**Murrindindi Planning Scheme Amendment C57 and
Planning Permit 2016/2**

1274 Whittlesea-Yea Road, Kinglake West

27 March 2017

Panel Report pursuant to Sections 25 and 96E of the Act

Figure 1 Exhibited site plan

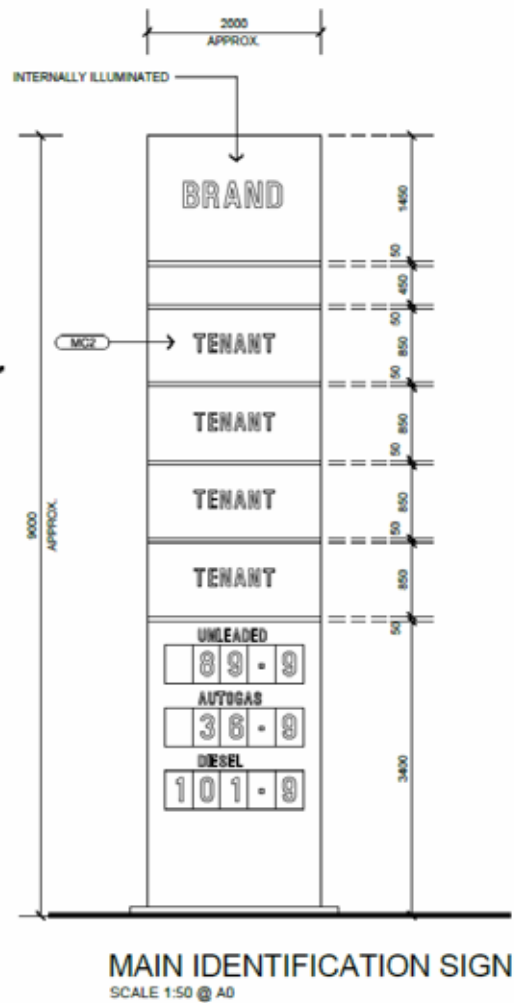
The exhibited plans show a boundary fence height of 1.65 metres and constructed of wood palings. The Panel supports the need for a higher fence and constructed of more durable material.

The Panel noted that the exhibited plan did contain the location of the LPG tank however the Revision E plans do not. The tank should be shown on the plans.

The Panel noted there was an error on the Revision E plans that showed the egress driveway increase its level of cut into the land on a decline in the topography, not on an incline. The levels on the site plan indicate that from the Whittlesea-Yea Road, the driveway rises and then falls down to the building envelope pad. This driveway is located 7.5 metres from the boundary to the residence further south. The Panel suggested at the hearing that, firstly there seemed to be an error in the plans (as above) and, secondly that it would be more appropriate to cut the driveway into the land so that it sits lower in the landscape than the residential property to the south and assist in providing a visual and acoustic screen to the residential property to the south. The Panel notes that the proponent and Council were supportive of this and has recommended a condition that this accessway not be lower than RL 510.35 metres.

Figure 5 Kinglake West-Pheasant Creek Design Framework

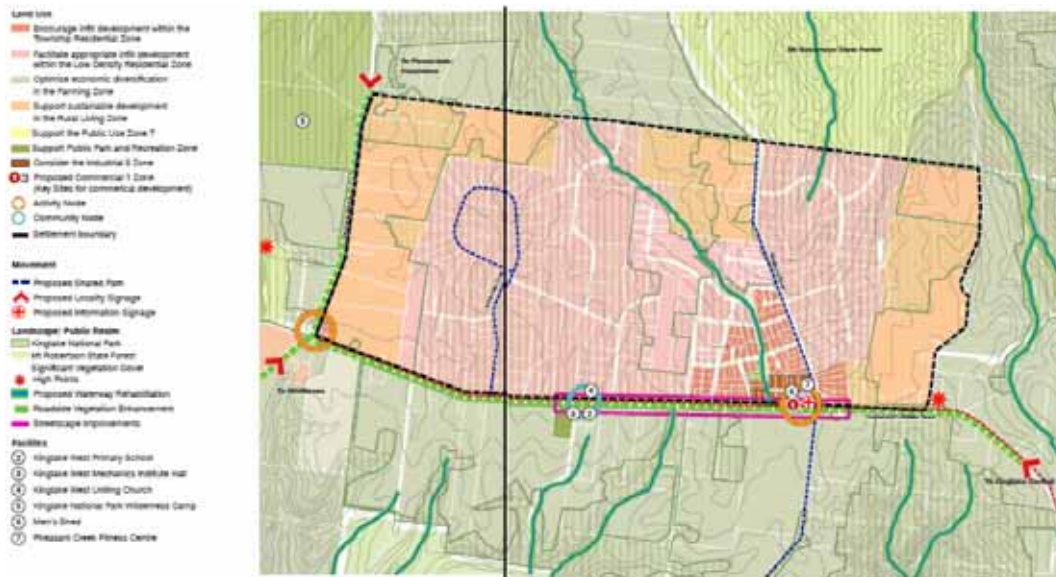
The KFT Plan is listed as a reference document in the planning scheme and used as a basis for the Kinglake West-Pheasant Creek Framework Plan at Clause 21.02. The designation of an activity node at Kinglake West is not reflected on the framework plan; neither is any other direction from the KFT Plan reflected in the LPPF. Therefore, there is significant reliance on a reference document that is not part of the planning scheme to justify this Amendment. A reference document is usually a background document to the planning scheme and if it is to be relied upon to make decisions then this information should be reflected in the Local Planning Policy Framework. Council should consider whether more

The Panel asked Council to identify which land was identified as key sites. Council advised that it did not have information to identify these sites, apart from a reference in the KFT Plan on the Kinglake West/Pheasant Creek Design Framework that identifies Kinglake as containing land proposed to be rezoned to the Commercial 1 Zone. This did not particularly assist the Panel, aside from confirming that Kinglake West does not contain any key sites.

KINGLAKE WEST – PHEASANT CREEK FRAMEWORK PLAN

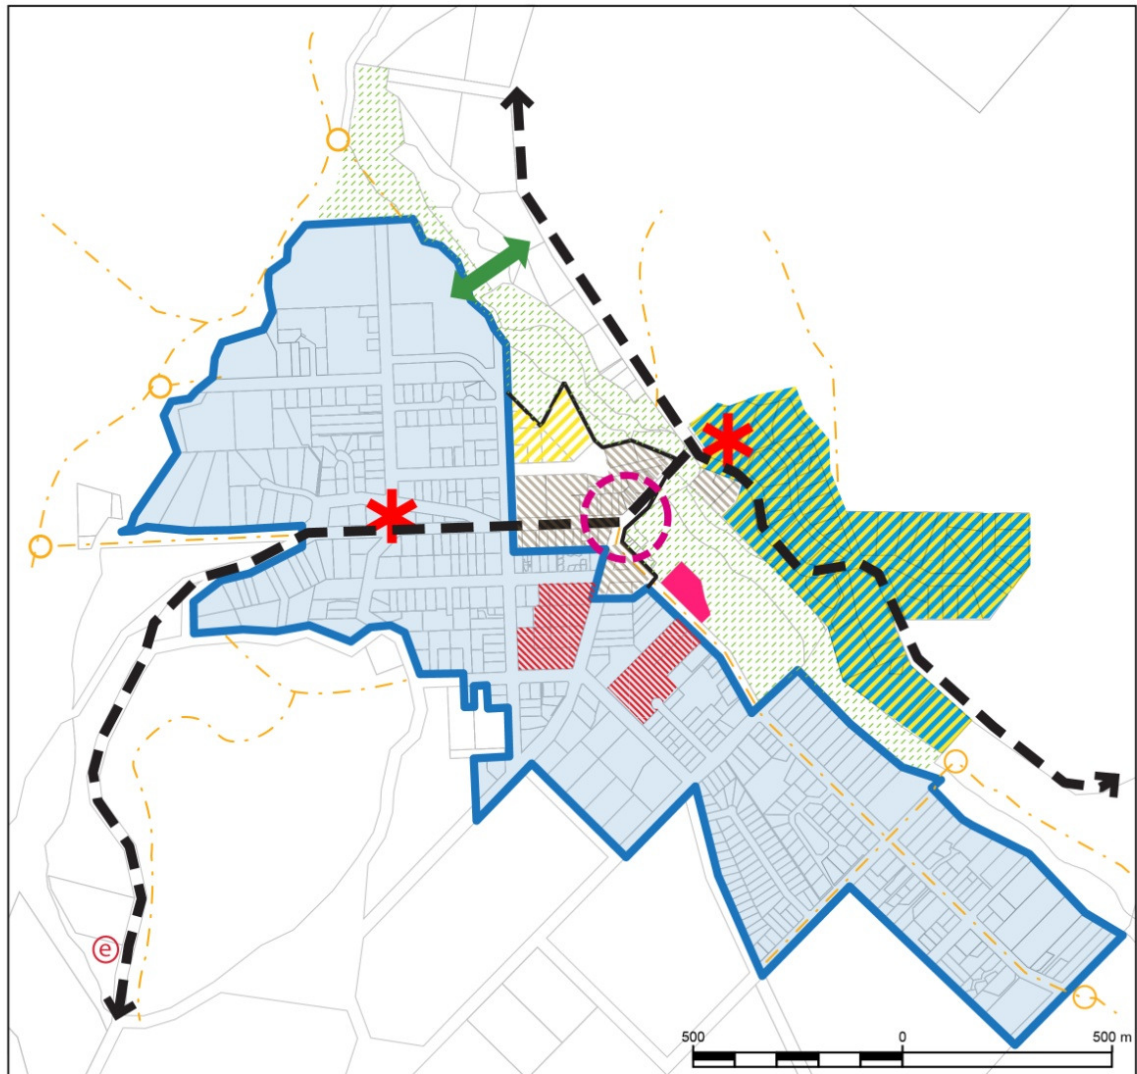
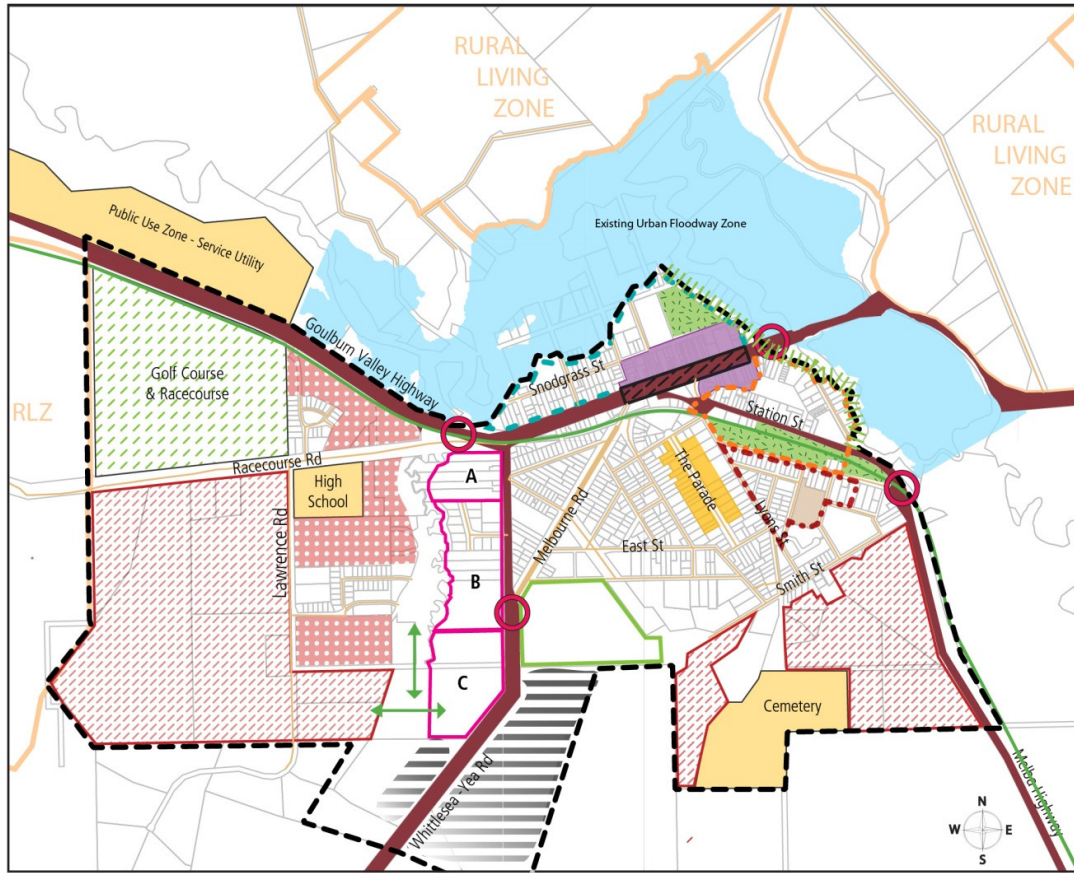
The Panel highlighted an anomaly that may be created by the rezoning. The Kinglake West-Pheasant Creek Framework Plan in Clause 21.02 classifies land according to the relevant zone. Accordingly, if the land is to be rezoned it would be prudent to amend the framework plan to show it in the TZ.

The Panel concludes it would be appropriate to amend Clause 21.02 (Kinglake West-Pheasant Creek Framework Plan) to show the land in the TZ.

Amend Clause 21.02, Kinglake West-Pheasant Creek Framework Plan, to show 1274 Whittlesea-Yea Road, Kinglake West within the Township Zone.
